ADDENDUM NO. 01

**PROJECT: Ossining Union Free School District
Ossining High School
Guidance Office Renovations**

DATE: December 22, 2020

CPL PROJECT NO: 14428.12

1 NEW WORK REFLECTED CEILING PLAN
SCALE: 1/4" = 1'-0"

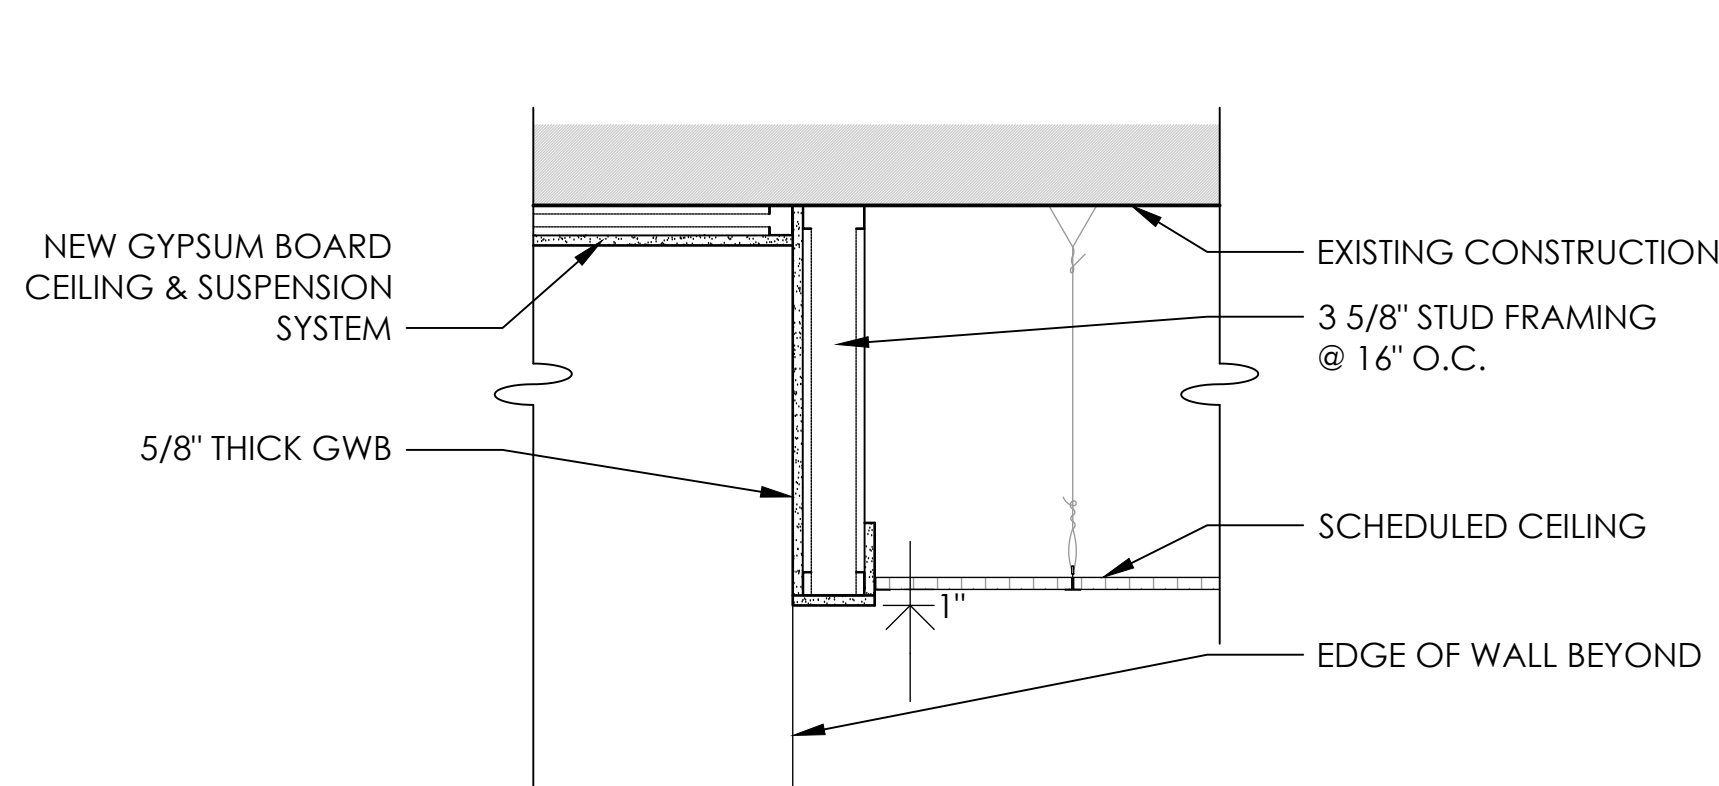
A. In paragraph 3.17.2: replace text '200 SF' to read '30 SF'.

OHS
H201
DRAWING NUMBER

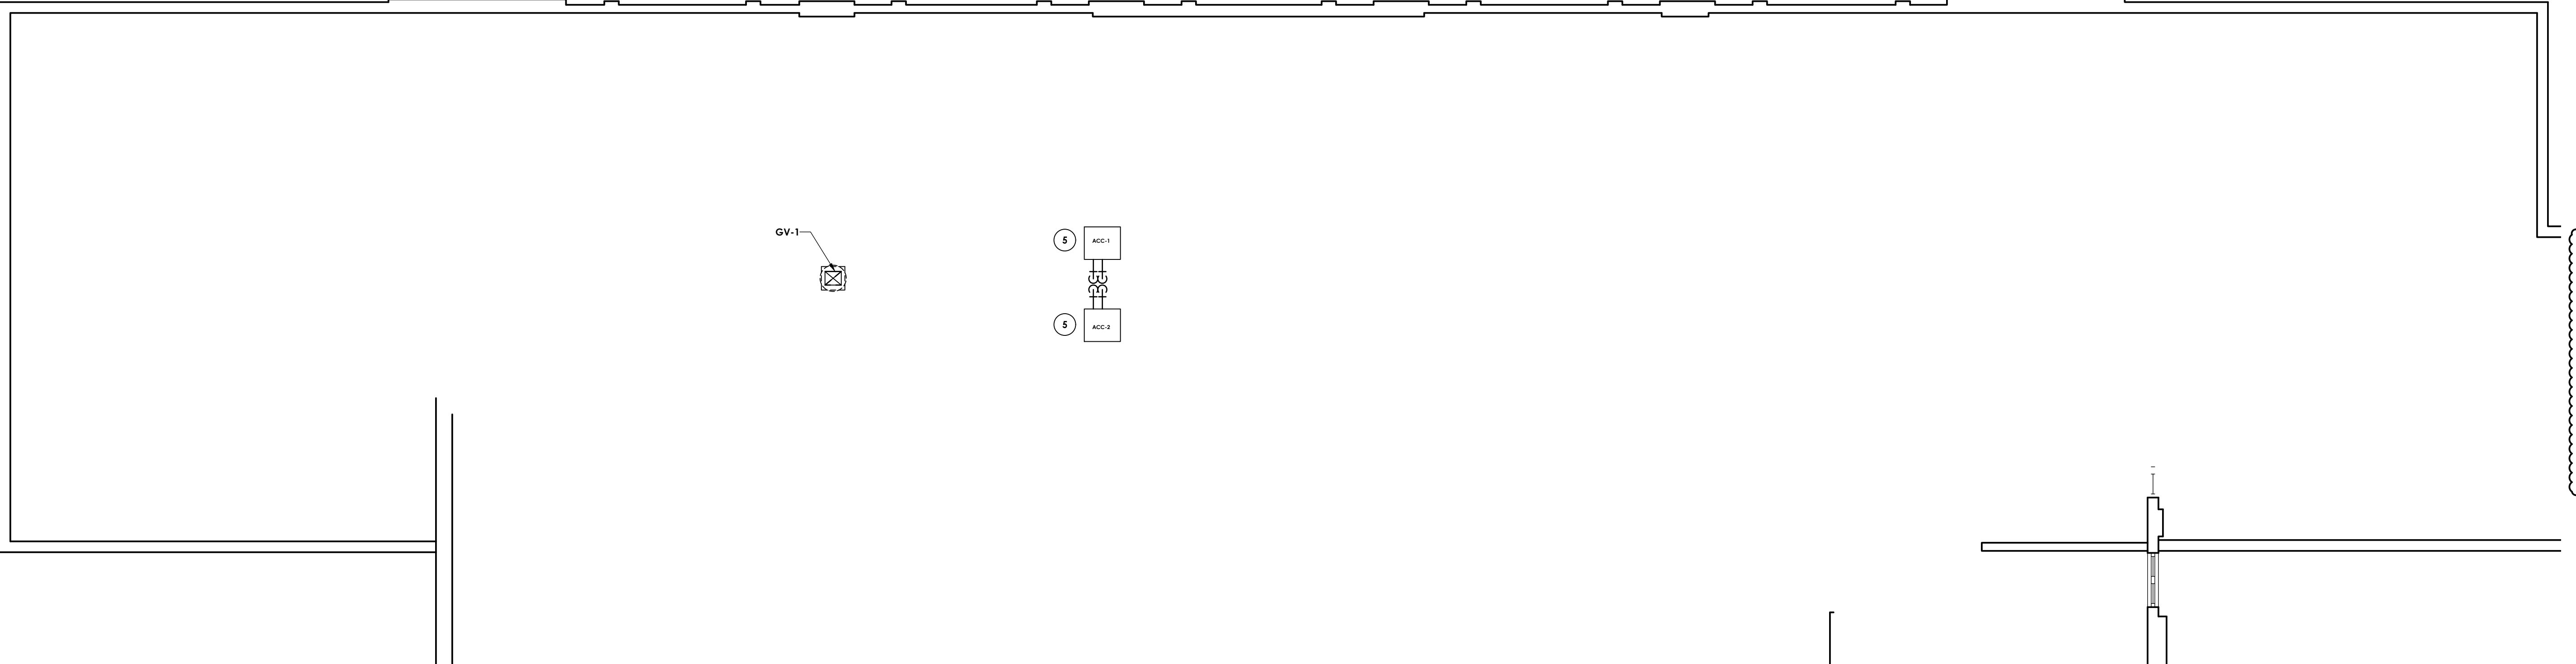
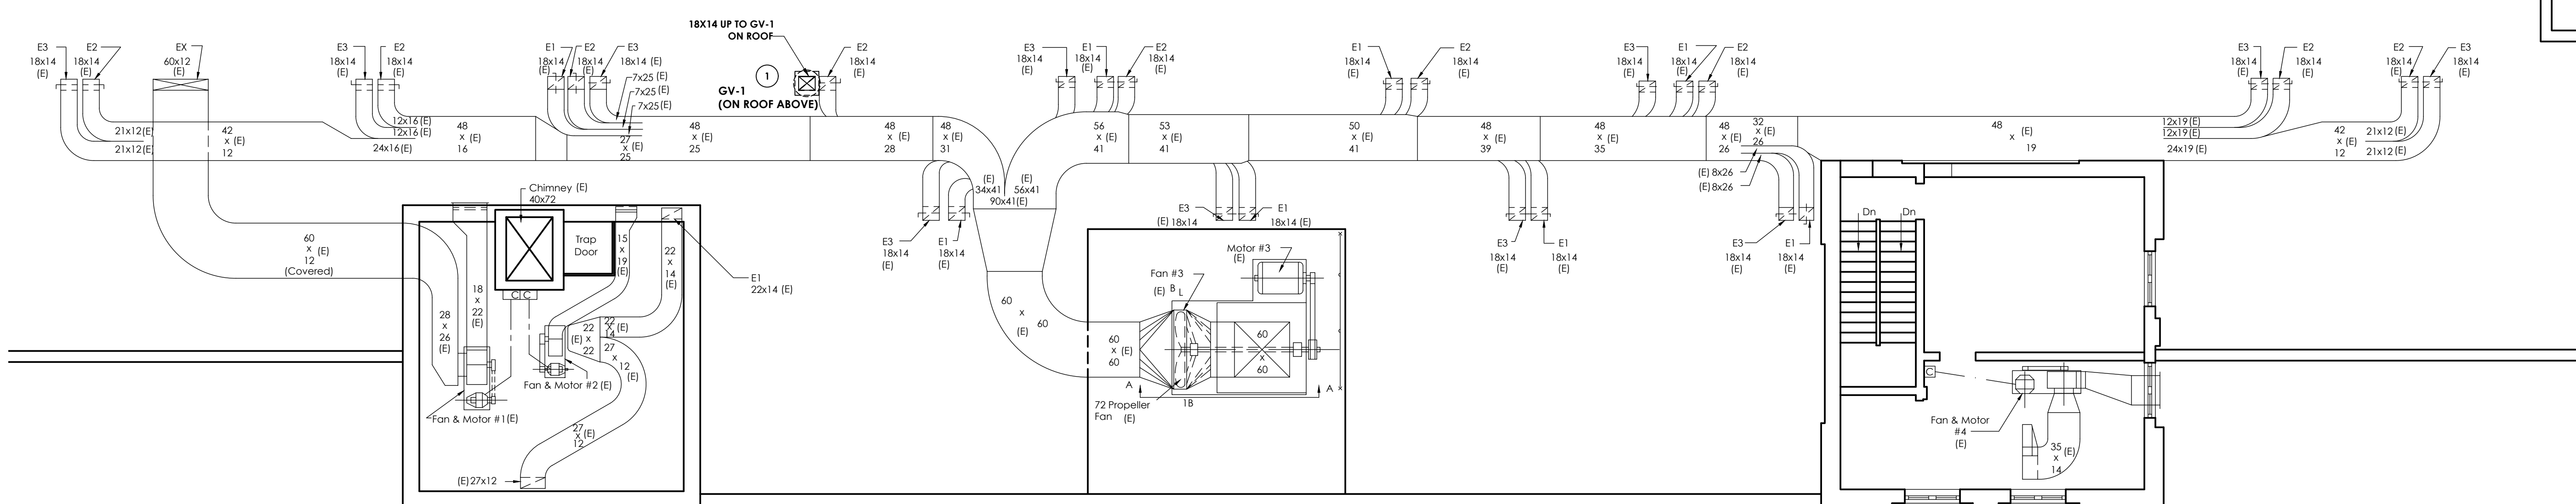
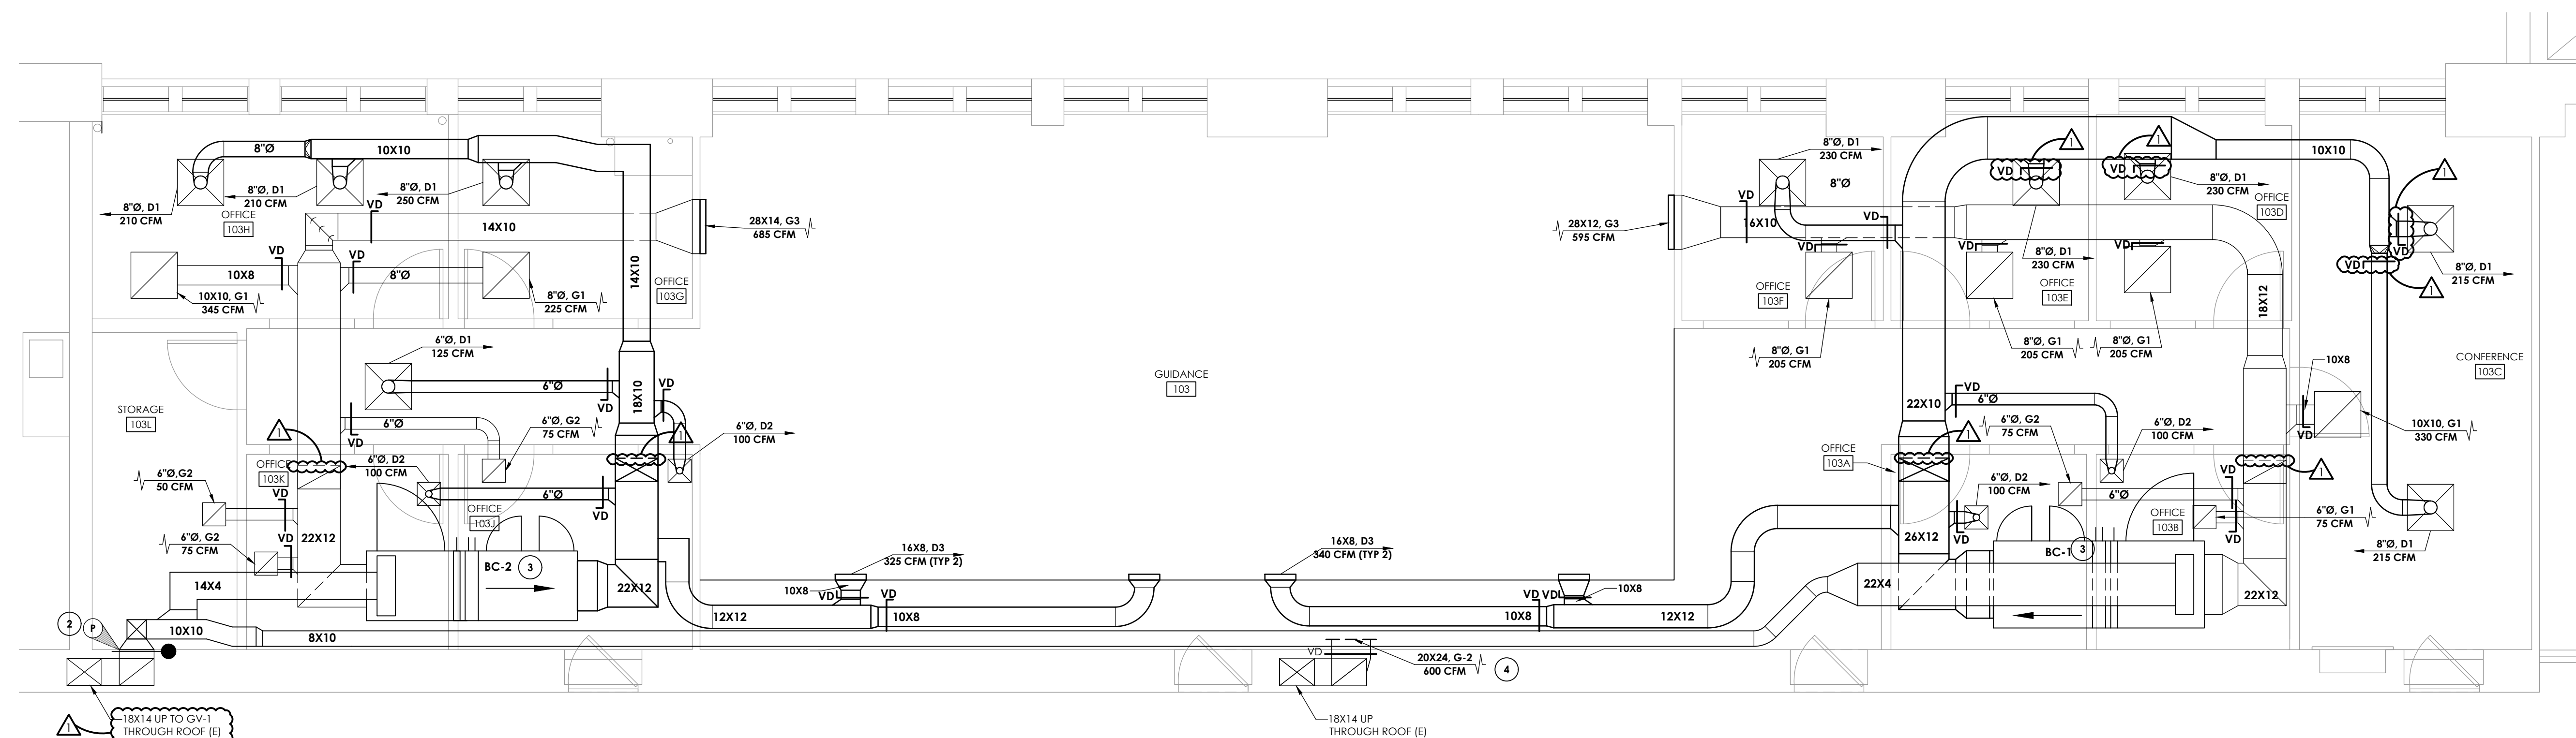
- 1.8** Question: AA102: Are we replacing roofing after abatement work? Are there roof drawings the Contractor can go by?
Answer: Roofing removed due to abatement operations shall be replaced maintaining all existing warranties. See Details 1/H101 and 1/H201.

OHS
H301
DRAWING NUMBER

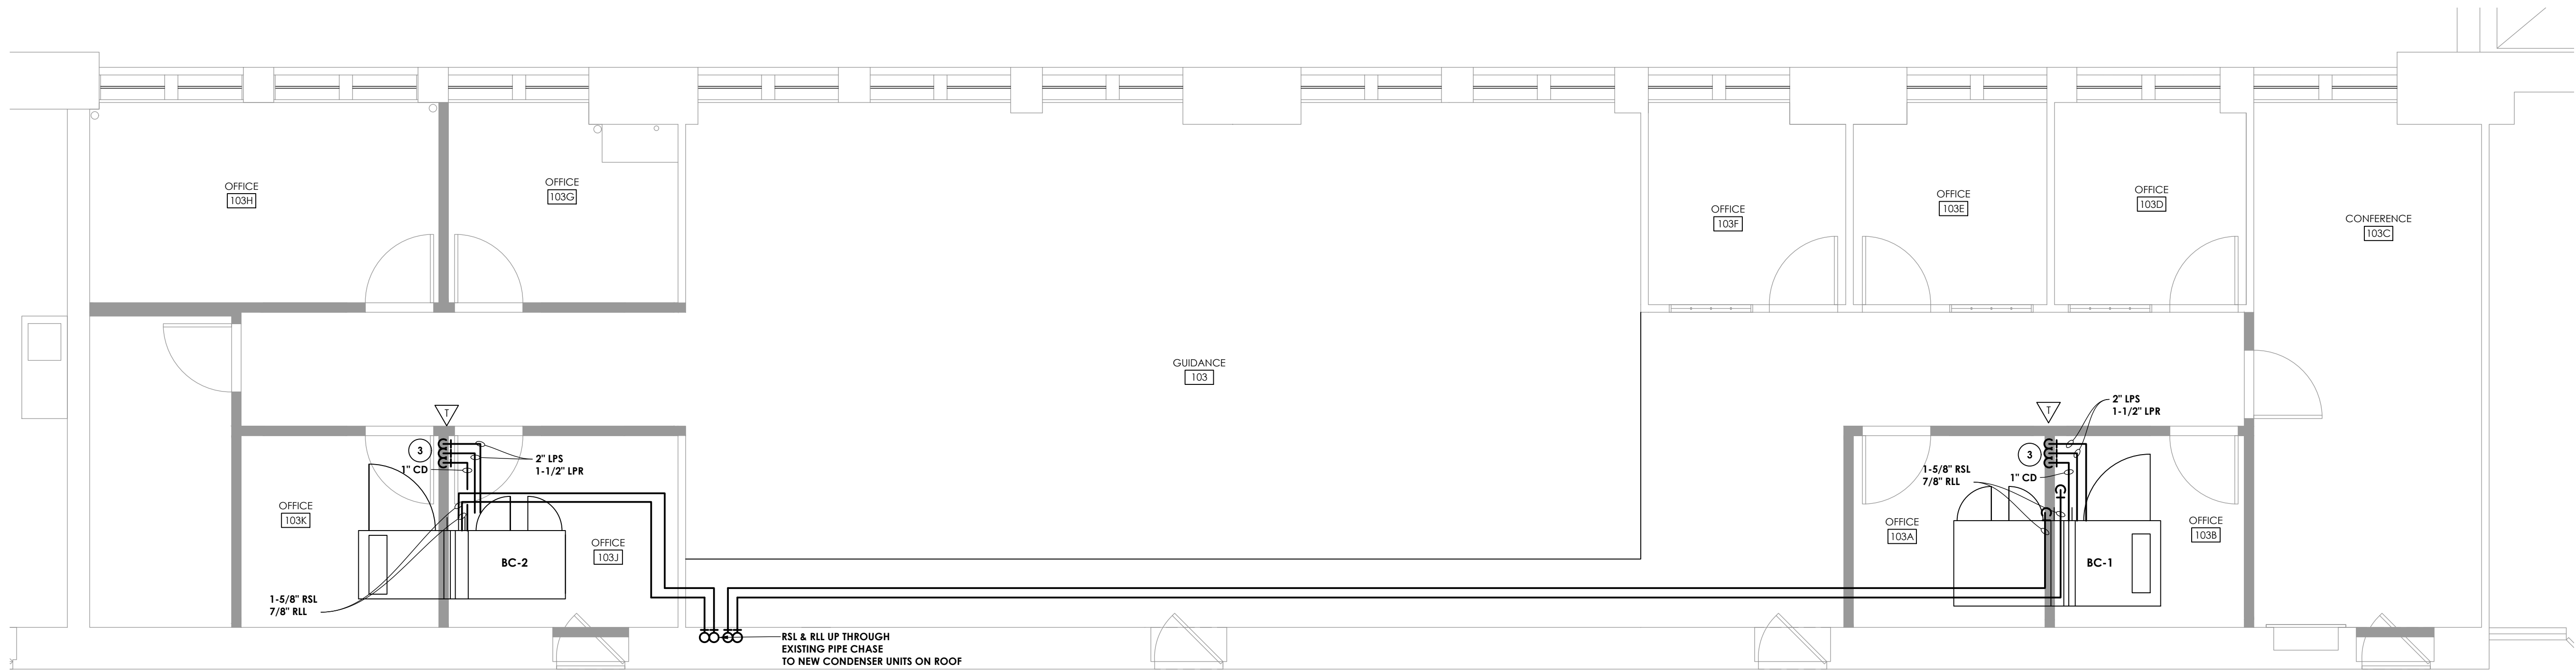
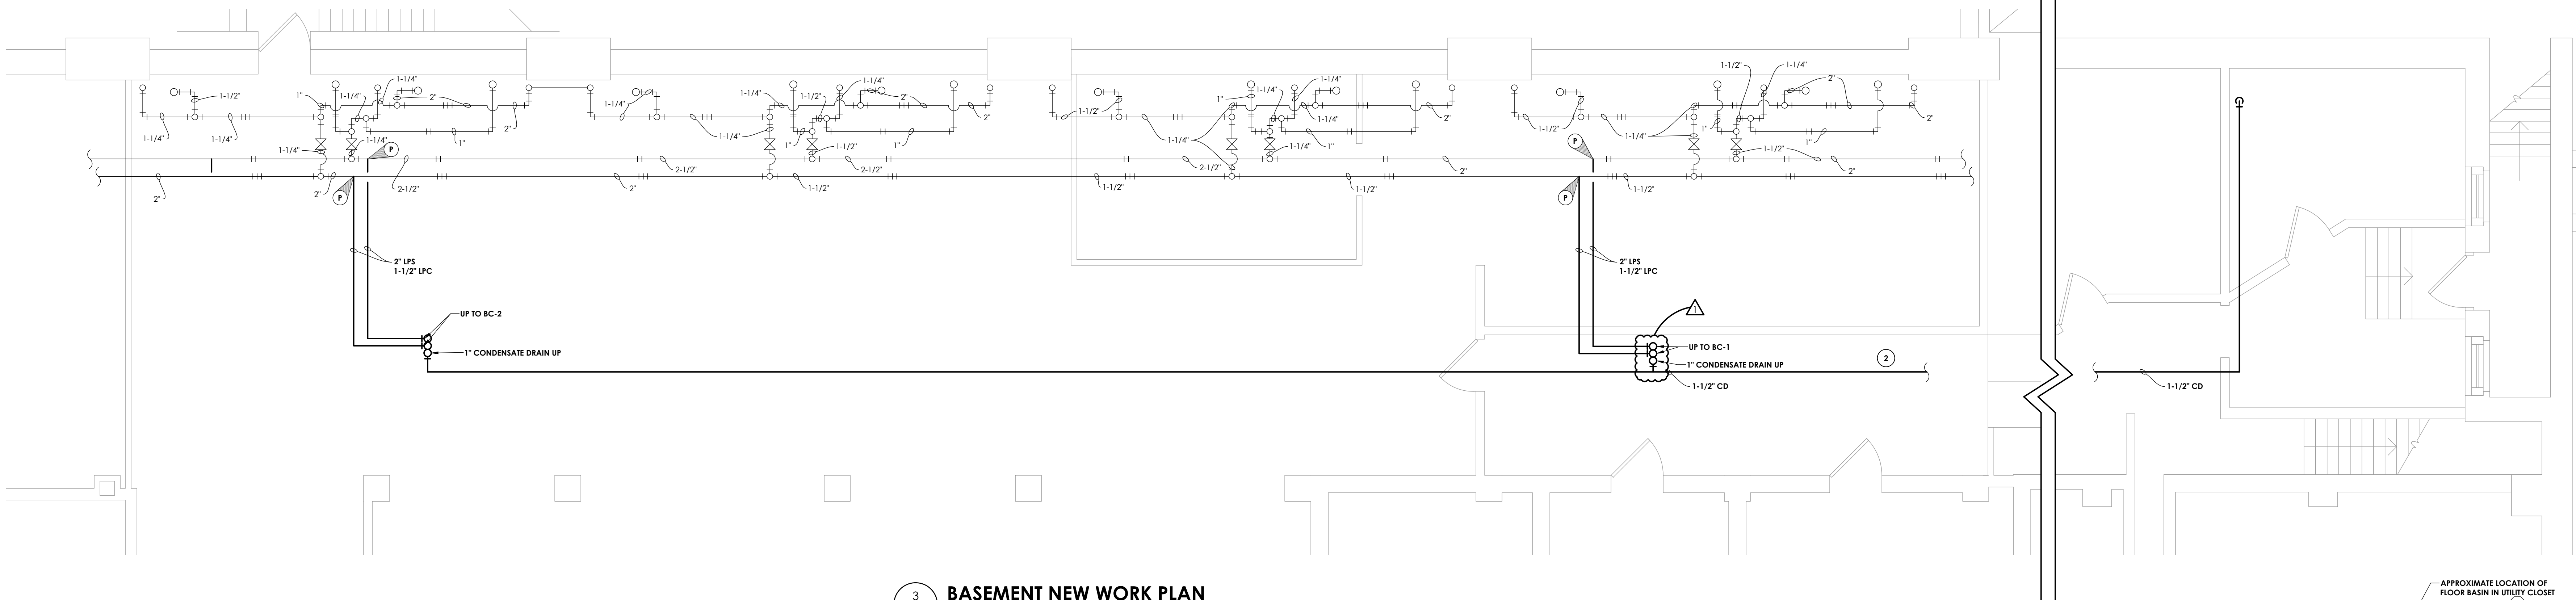
- 1.9** Question: AA102: Are we replacing the tile after we remove the MJ's?
Answer: It is the assumption that the question refers to the 'square' hatching used to show work area. Scope of work is to remove MJ's and debris in attic. See Section 02 0800, Paragraph 3.17.1. Note that reinsulating all piping where insulation was removed is part of the work. See H301, H302.

Answer: It is the assumption that the question refers to the 'square' hatching used to show work area. Scope of work is to remove MJP's in the basement. See Section 02 0800, Paragraph 3.17.1. Note that reinsulating all piping where insulation was removed is part of the work. See H301, H302.

1.11 Question: How much reinsulation of piping do we need to figure after abatement? Note that H302 says to replace 200 LF, but note H301 says to replace 135 LF.

Answer: 335 LF.
